Re: Turkey Point Units 3 and 4  
Docket Nos. 50-250 and 50-251  
St. Lucie Units 1 and 2  
Docket Nos. 50-335 and 50-389  
Topical Quality Assurance Report (FPLTQAR 1-76A)

Pursuant to 10 CFR 50.54(a)(3) attached is the annual update of the Florida Power and Light Company (FPL) Topical Quality Assurance Report (TQAR).

Enclosure 1 includes a summary of the changes made to the TQAR. Enclosure 2 is the current TQAR including all revisions issued through Revision 197 dated December 21, 2005.

**Florida Power Light**  
**Topical Quality Assurance Report Change Summary**  
**June 2006**  
**(Page 1 of 4)**

TOPICAL QUALITY ASSURANCE REPORT	REVISION 52
ORGANIZATION OF DEPARTMENTS AFFECTING QUALITY FIGURE 1-1 APPENDIX A NUCLEAR DIVISION	12/09/05
	PAGE 2 OF 2

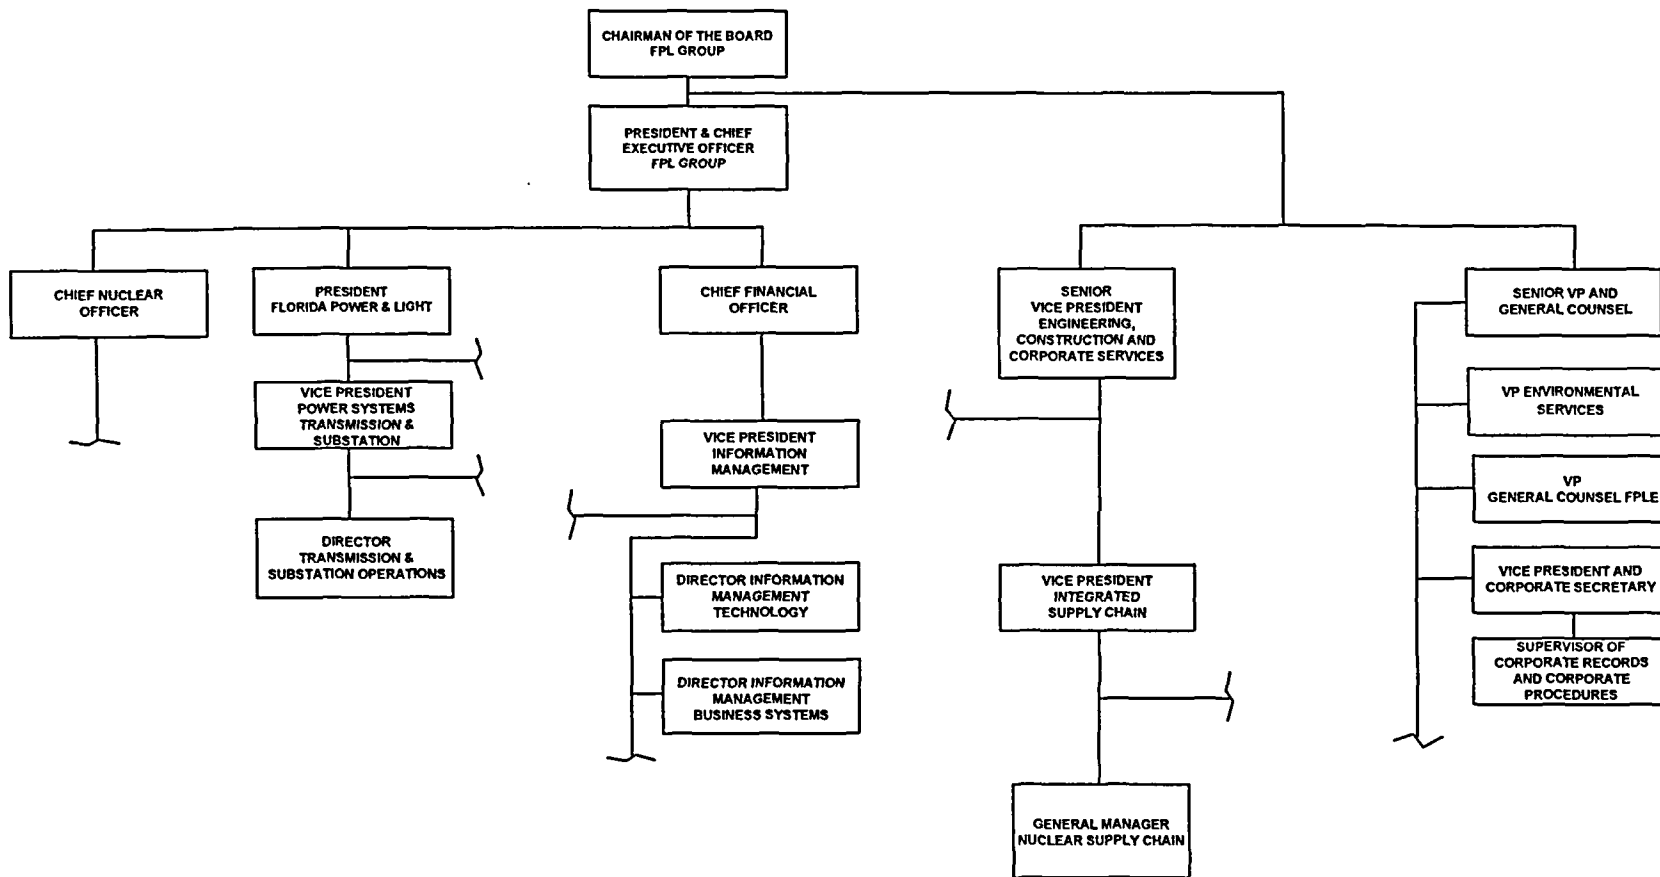
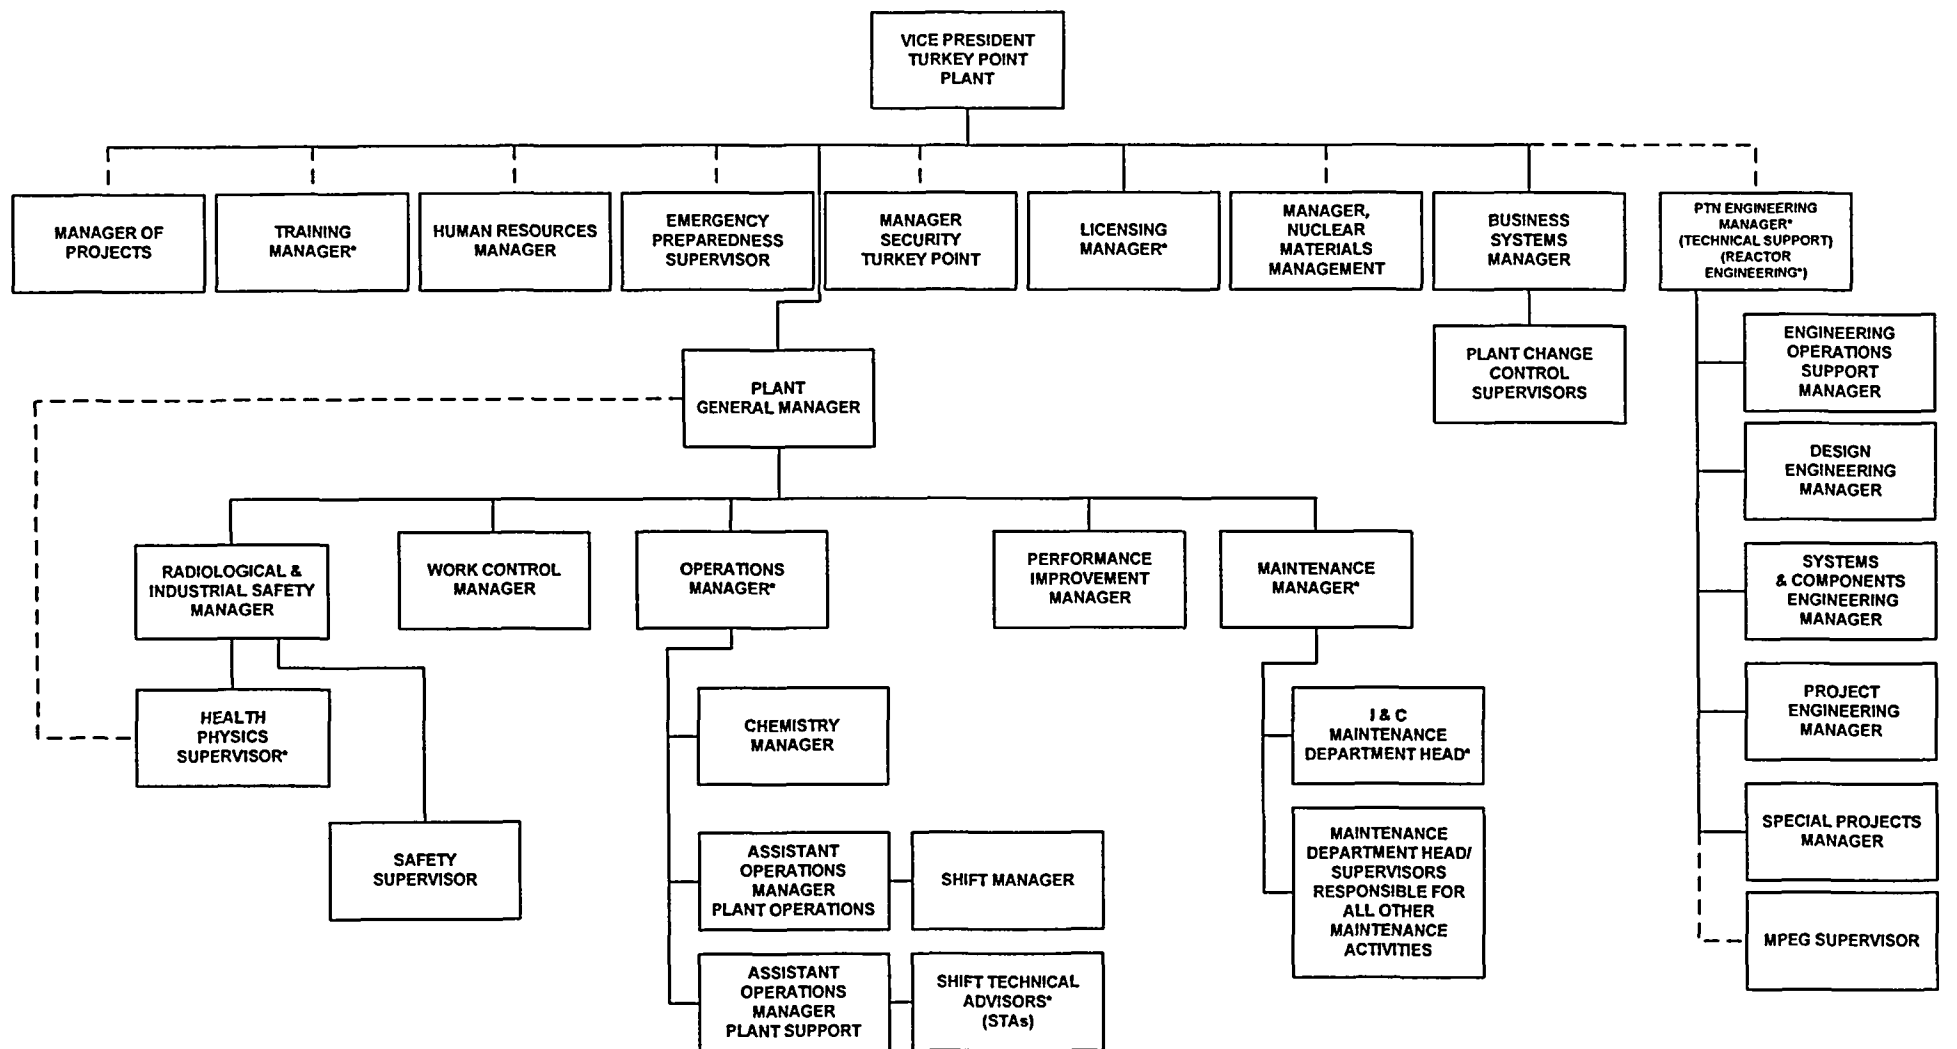
Appendix G Revision 3 12/09/05 (Revision 196)	1	Delete references to the Services group. The PSL Organization has been restructured and the responsibilities of the Services group were reassigned to other groups. [Paragraph 6.5.1.2]	Organizational change only--Resulting from an organizational restructuring. Functions now reside in other organizational groups.
